INDEPENDENT EXPERT ADVISORY PANEL FOR MINING

CHAIN VALLEY CONSOLIDATION PROJECT (SSD-17017460)

Subsidence Impact Assessment

IEAPM Report No. 202412-1

Figure 3. Proposed herringbone first workings layout for Zone A
(source: Umwelt Report, attached Byrnes Geotechnical Report (October 2023))

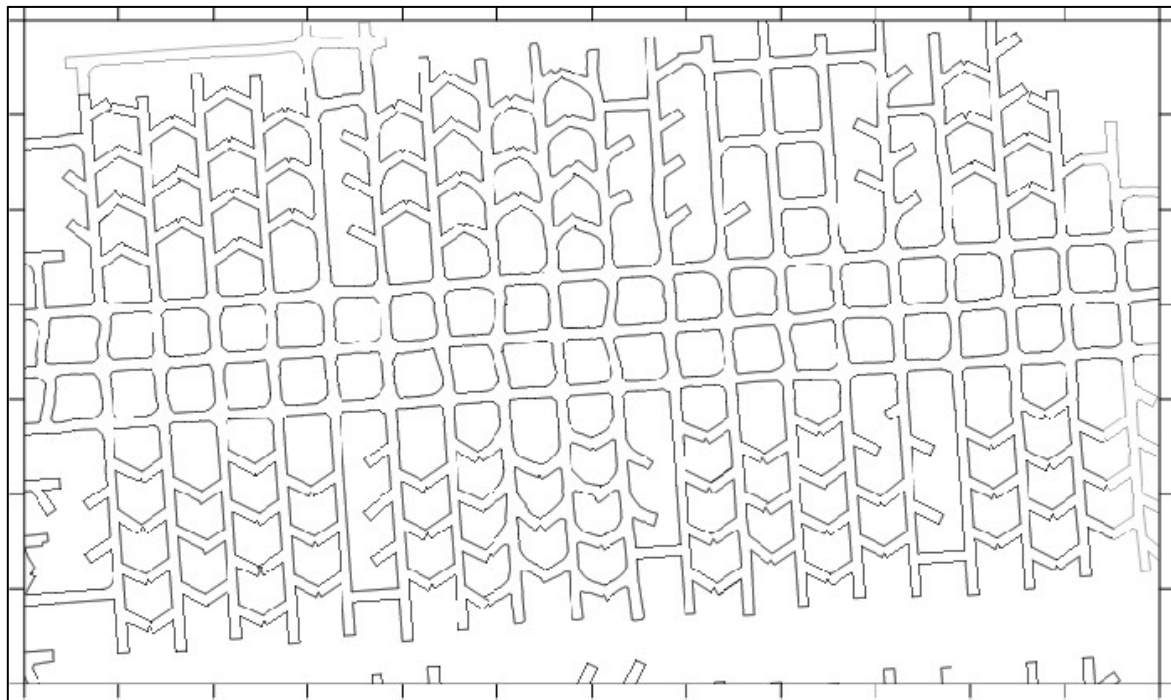
The Panel has reviewed the Zone A layout design and the analysis and validation documentation provided by Byrnes Geotechnical, through Umwelt/Delta Coal. This has involved a number of iterations

in the review process following questions raised by the Panel and further responses provided by Delta Coal. Delta Coal contends that the proposed first workings layouts in Zone A will result in less than 20mm of vertical subsidence (mining-induced).

One of the major concerns that the Panel has with the proposed workings under the current Zone A consent condition limitation of 20mm maximum subsidence is not that the first workings layout may not be compliant with such a condition, but with the extreme difficulty in differentiating between natural variations in surface ground movement (due to factors such as clay swelling, shrinkage, weathering etc) and mining-induced movements at such low levels. This is particularly the case where surface soils and related strata contain clay-bearing material which is particularly susceptible to moisture effects. The Ruttleys Road data, and other survey results, may well be impacted by such non-mining ground movements, and it has not been possible to identify the magnitude of such movements other than recognising from non-mining locations that the magnitudes of non-mining movements can be greater than the 20mm limit being imposed on mining-induced subsidence.

Delta Coal has provided the calculations used to determine pillar stability for the proposed herringbone panel layouts. The Panel recognises that use of the commonly adopted pillar strength determination formulae requires some assumptions and approximations to be applied to these types of more complex pillar shapes. Nevertheless, the Panel is satisfied with the approximations and overall methodology adopted by Delta Coal for the herringbone pillars, even though the Panel remains to be convinced on some points of detail.

An area of concern with respect to the pillar design relates to the presence of potentially weak/soft claystone strata in both the immediate floor and roof adjacent to the coal seam. These strata horizons have the potential to contribute to different forms of underlying (and overlying) foundation failure when the pillars are more highly loaded. The Panel understands that Delta Coal has taken account of these issues in relation to the presence of claystone in the floor. However, the question of claystone in the roof is a matter that may require further localised mine plan design variations on a panel-by-panel basis, depending on the local roof geology.

1. The Department should consider replacing the current 20mm subsidence limit for Zone A workings with a negligible impact set of mining consequence criterion for all relevant parameters (including the built infrastructure), noting that this should achieve the same objectives as those intended to be achieved by the now legacy issue of specifying an extremely low level of permissible subsidence, such that it becomes an impractical and unmanageable control in practice.

2. Further design criteria should be specified for first workings, being that these workings should be designed to:
 - a. be long-term stable, and to
 - b. exhibit no ongoing time-dependent deformation either within the coal pillars themselves, or the immediately surrounding roof or floor strata.

Figure 4. Proposed double-sided lifting secondary extraction layout for Zone B
(source: Umwelt Report, attached Byrnes Geotechnical Report (October 2023))

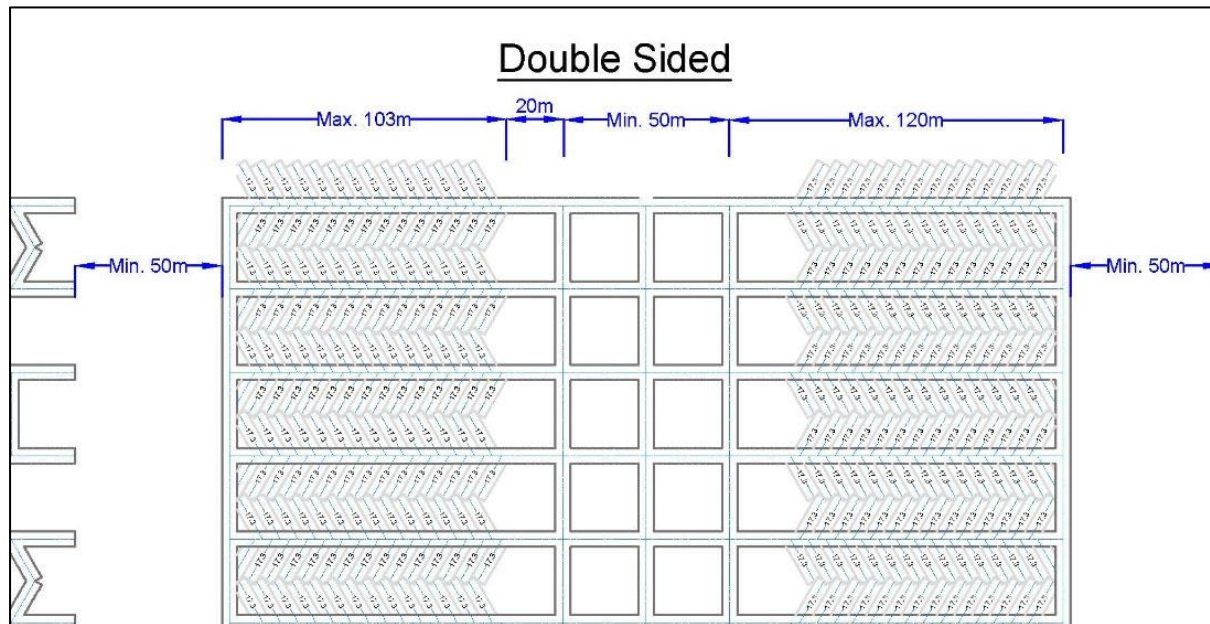
The current consent conditions require that the subsidence above such panels does not exceed 780mm. The design of the proposed secondary extraction panels by Delta Coal's geotechnical consultants is primarily based on a reliance on the bridging effect of the massive overlying conglomerate strata (Teralba Conglomerate Unit) present in the overburden above the Fassifern Seam. On the basis of the above proposed panel layouts (both extraction widths and barrier pillar widths) a maximum subsidence of 475mm has been predicted by Delta Coal.

Delta Coal has conducted a number of sensitivity studies in its design analysis, based on different thicknesses and strength/stiffness of the overlying conglomerate unit. An average strength (UCS) of 65-MPa has been used, representing a range of values between 12 MPa and 108 MPa. (This wide range illustrates the need to consider site-specific values for each panel/barrier region of the proposed workings). Similarly, the conglomerate thickness has been described as approximately 40m, and a design figure of 30m has been used. However, the data presented includes reference to conglomerate thickness as low as 20m.

Clearly, such a low thickness, combined with some low strengths, could lead to significantly different spanning capabilities.

1. Should the CVCP be approved, approval conditions should provide for:
 - a. local conglomerate and claystone properties and thicknesses to be investigated for each set of extraction panels prior to finalising extraction and barrier width parameters.
 - b. the overall number of panels in any location be limited to no more than two, without the inclusion of a more substantial barrier separating adjacent mining regions.
 - c. staged approval of Extraction Plans for second workings, premised on predicted versus measured performance.

Figure 6. Cross-sectional survey data from 2018 to 2024 – Miniwalls S2 to S5
(source: Delta Coal Response Report (October 2024))

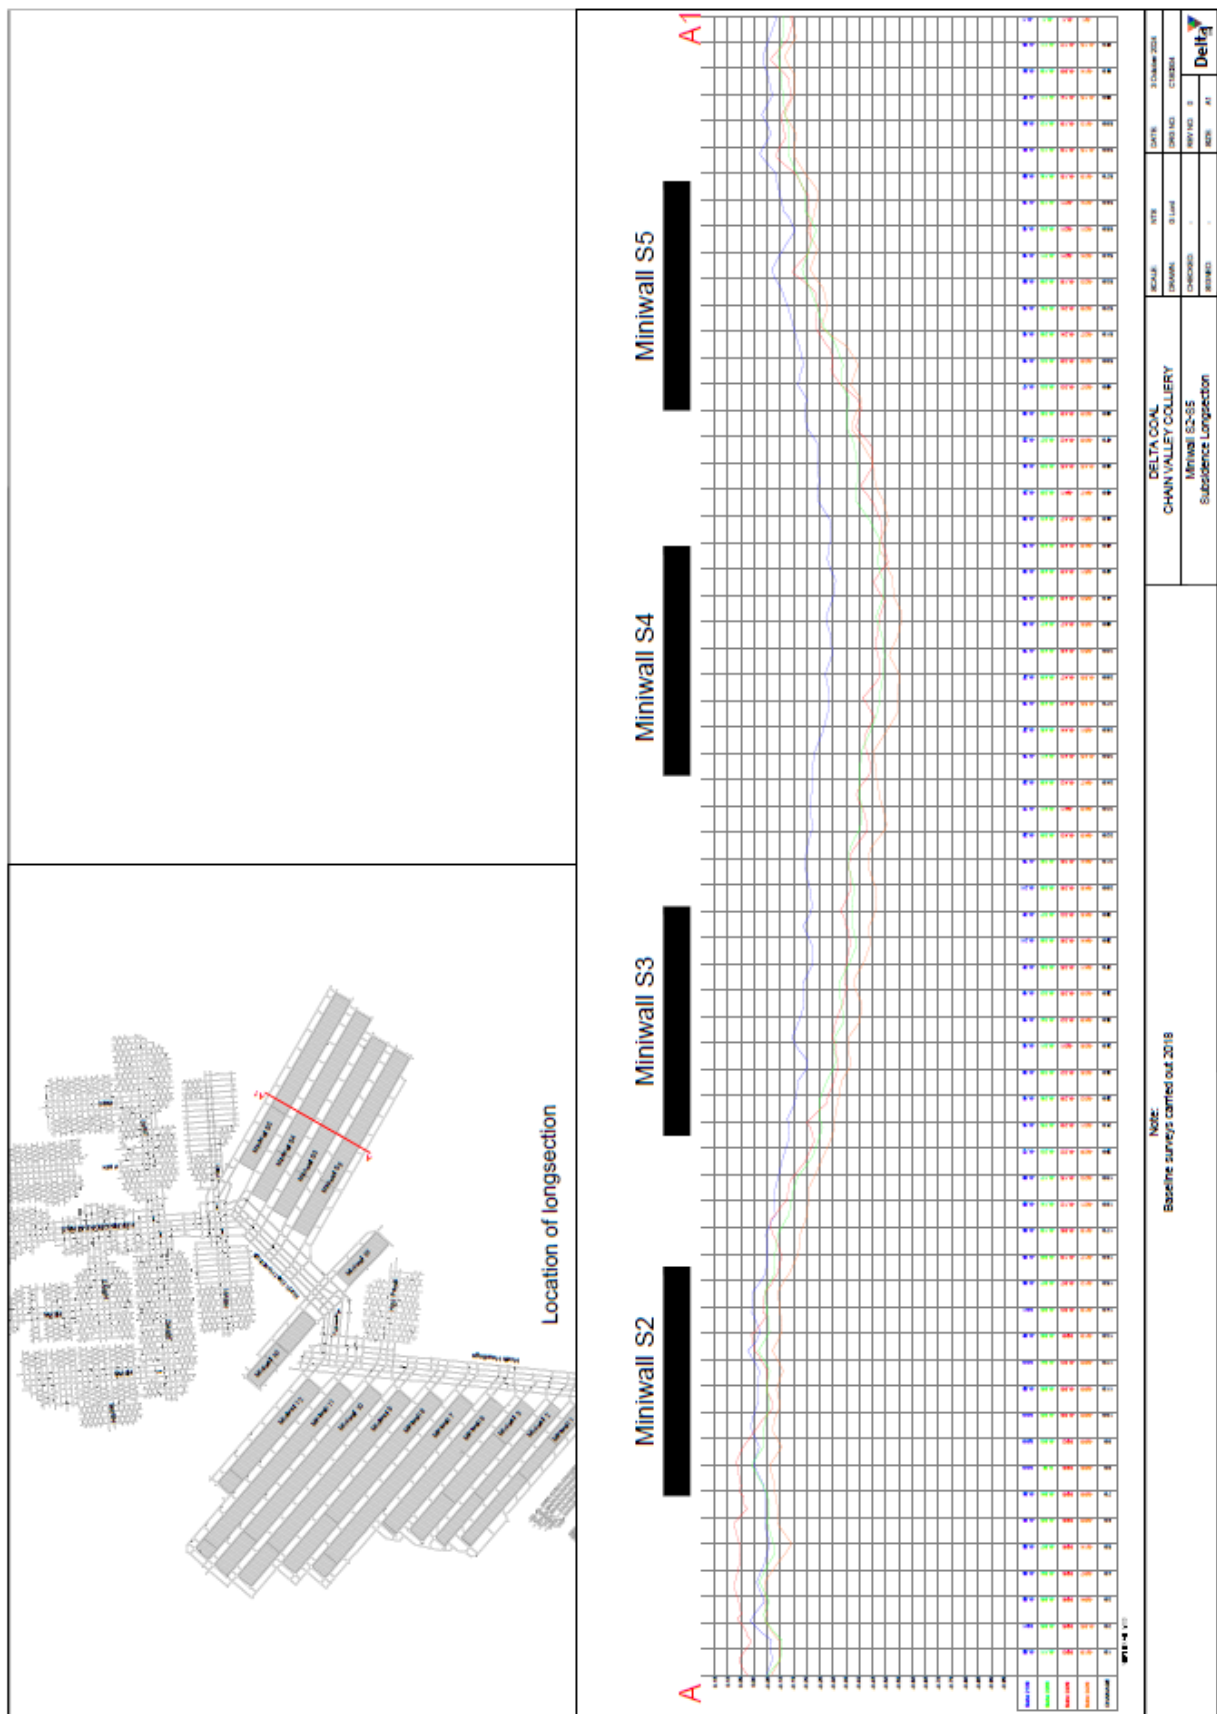
The S2 to S5 survey data (Figure 6) is taken from a pre-mining baseline of 2018, with the surveys taking place in September of each of 2021, 2022, 2023 and 2024. Whilst these results indicate that the majority of subsidence was complete by 2022, there is some indication that a low level of ongoing movement may still be occurring, even in 2024.

Figure 7. Cross-sectional survey data from 2018 to 2024 – Miniwalls 1 to 12
(source: Delta Coal Response Report (October 2024))

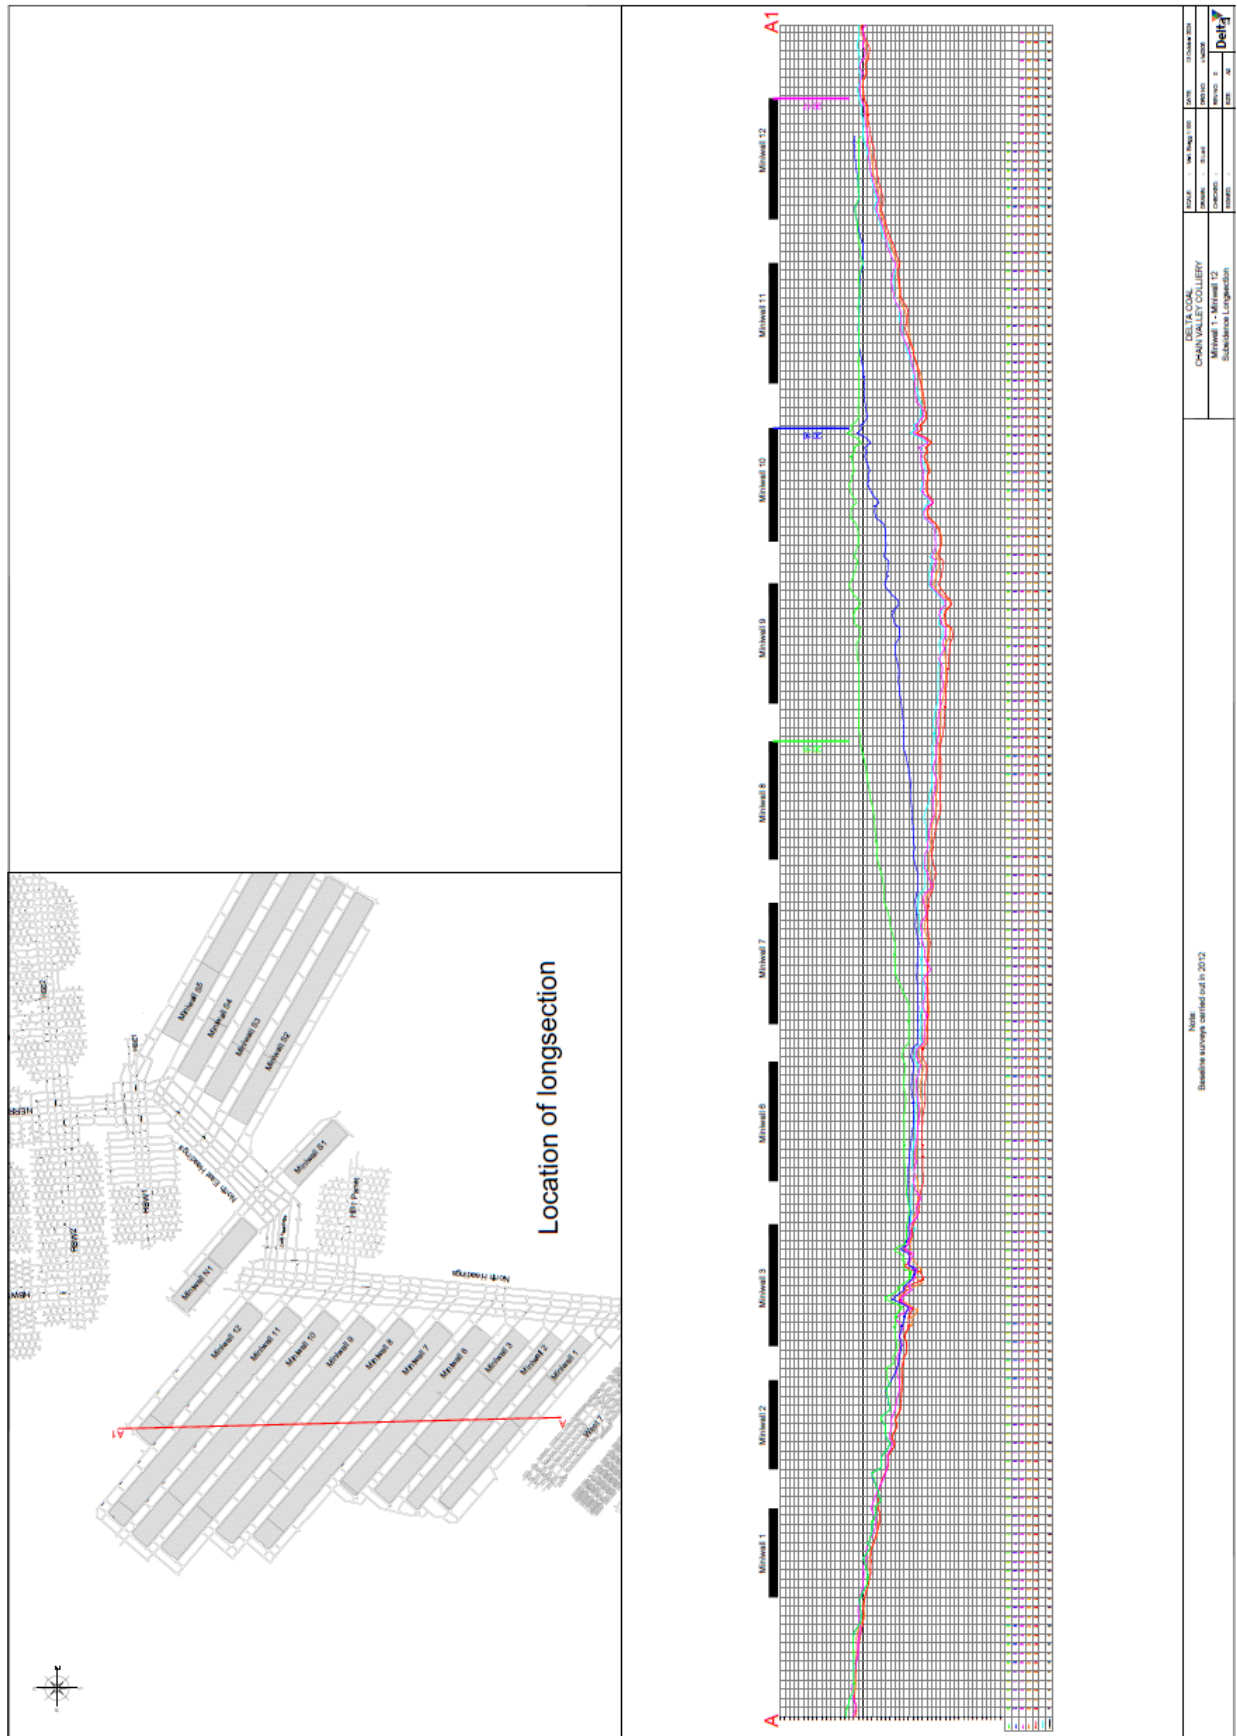
The Miniwall 1 to 12 data in Figure 7 presents survey data after mining, in 2015, 2016, 2017, 2018 and two surveys in 2019. This data appears to indicate a more stabilised set of results over time, although there is no data after 2019 to provide full verification that subsidence has plateaued.

The Miniwall 1 to 12 panel layouts involved barrier pillar widths of only 33m and led to a maximum subsidence level of 1,150mm developing over the centre of the twelve-panel extraction region, compared to the predicted level of only 720mm, in contrast to the S2 to S5 panels where wider (40m) barrier pillar widths were used.
